BAMx Comments on the CAISO Draft 2012-13 Transmission Plan

The Bay Area Municipal Transmission group (BAMx)¹ appreciates the opportunity to comment on the Draft CAISO 2012-13 Transmission Plan (Draft Plan) dated February 2, 2013, which was discussed during the Stakeholder meeting on February 11, 2012. The comments and questions below address both the Draft Plan and the February 11th Stakeholder meeting. We hope that the CAISO addresses these issues in its Final 2012-13 Transmission Plan.

Figure 1: Estimated Economic Benefits of the Two Economic Study Projects Under Multiple CAISO Findings

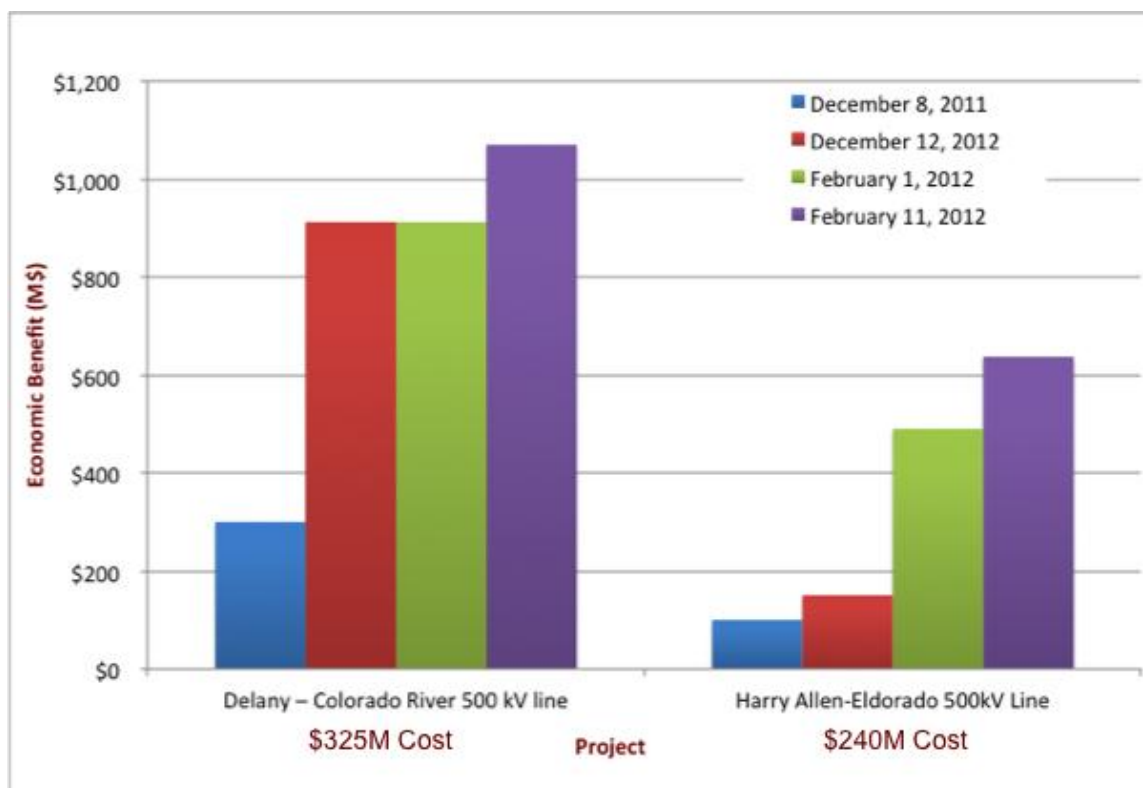
The Draft plan has recommended the *Delany – Colorado River 500 kV line* project for approval and has recommended the *Harry Allen – Eldorado 500 kV line* project for further study in the ongoing CAISO-NVE joint study. We have noticed that the estimated benefits associated with these two projects have gone up significantly under multiple CAISO reporting since last year as shown in Figure 1 below. The CAISO has provided little documentation in the Draft Plan on the reasons for such major changes in estimated benefits associated with these transmission projects. We request that the CAISO provides justification for these changes as well as arguments, if any, on why the final benefits calculations that were presented in the February 11th stakeholder meetings should be trusted to approve transmission projects costing hundreds of millions of dollars.

Furthermore, we find that the Net Present Value (NPV) calculations of the benefits of the candidate transmission projects to be questionable. For example, for the *Harry Allen – Eldorado 500 kV line* project, the CAISO calculated the total benefits in years 2017 and 2022 as **\$87M** and **\$33M**, respectively. Our understanding is that the CAISO interpolated these benefits for the intervening years and extrapolated the benefit of \$33M in years 2023 onwards at 1% annual escalation. We question the CAISO’s rationale for such extrapolation of economic benefit. The CAISO has estimated the NPV of benefits over 50 years discounted at 7% to be **\$637M**. We have verified these calculations. However, when we apply a trend on the benefits to extrapolate them beyond 2022 taking into account a significant drop in the benefits from 2017 to 2022, we get a NPV of benefit of **\$327M** over 50 years, nearly half as much as benefit calculated by the CAISO.⁴ This exercise demonstrates that the CAISO’s calculation of the benefits based on only two years of data is highly susceptible to how the extrapolation of these benefits are calculated. BAMx believes that it is important to recognize why the benefit has dropped from 2017 to 2022, the likely reason being the increased buildup of the low variable cost renewables within the CAISO BAA. If the renewable buildup continues to go up within the CAISO in the later years, it is likely that the benefit of the out-of-state (OOS) transmission projects like *Harry Allen – Eldorado 500 kV line* will go down.
